# ***Council Decision on Proposed District Plan Change 60***

**Churton Park Suburban Centre rezoning**

## REPORT OF THE HEARING COMMITTEE

**SUBJECT:** PROPOSED DISTRICT PLAN CHANGE 60 - REZONING OF THE CORNER OF WESTCHESTER DRIVE AND LAKEWOOD AVENUE FROM OUTER RESIDENTIAL TO SUBURBAN CENTRE

## **Appendix 89 Churton Park Village Concept Plan**

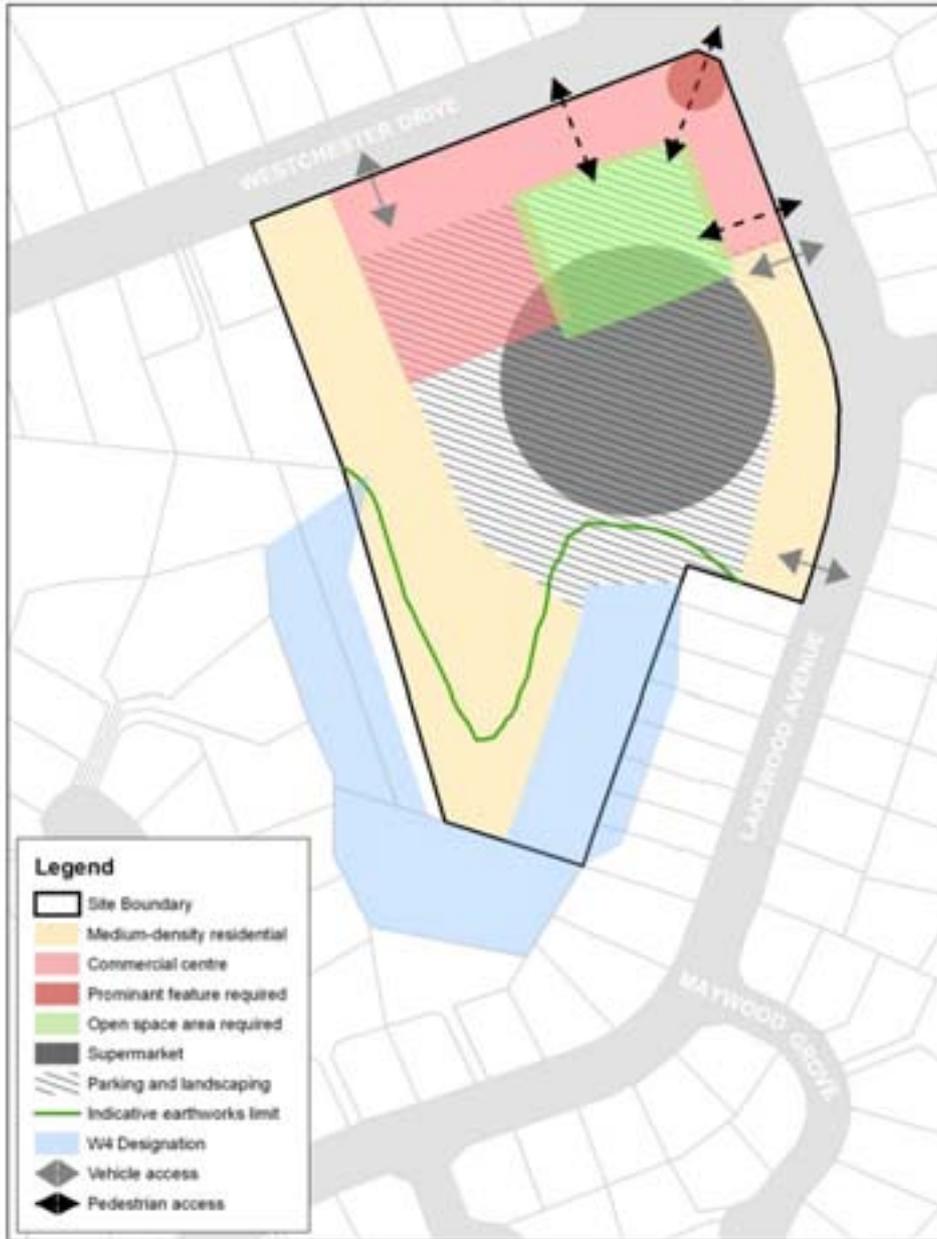
Submission 10 from Greater Wellington Regional Council seeks that the designation area shown on the concept plan be amended as it is incorrectly identified. An access to the W4 area is sought for maintenance purposes, and the submission seeks that an Open Space A zone be included around the periphery of the site above the designation area to restrict future development and further protect the designation area. The Regional Council appeared at the hearing and provided substantive information on the background to the W4 designation area in support of its submission.

**Accept** submission 10 insofar as it requests the concept plan map be amended to correctly show the designation area, and to require the provision of vehicle access down to the stream in the gully within the designation area.

- (a) Amend the Churton Park Village Concept Plan Map to correctly show the W4 designation area.
- (b) Include a new requirement, no. 16, for a 3m wide formed access to be provided from Lakewood Avenue to the W4 designation area:

- (e) Amend the Churton Park Village Concept Plan Map as shown in appendix 4

- (c) Amend the Churton Park Village Concept Plan Map as shown in attached version.
- (d) Amend requirement 6 under Section 4.0 Requirements to clarify that the green open space area shown on the concept plan map is an indicative size and shape and does not represent exactly what will be developed:
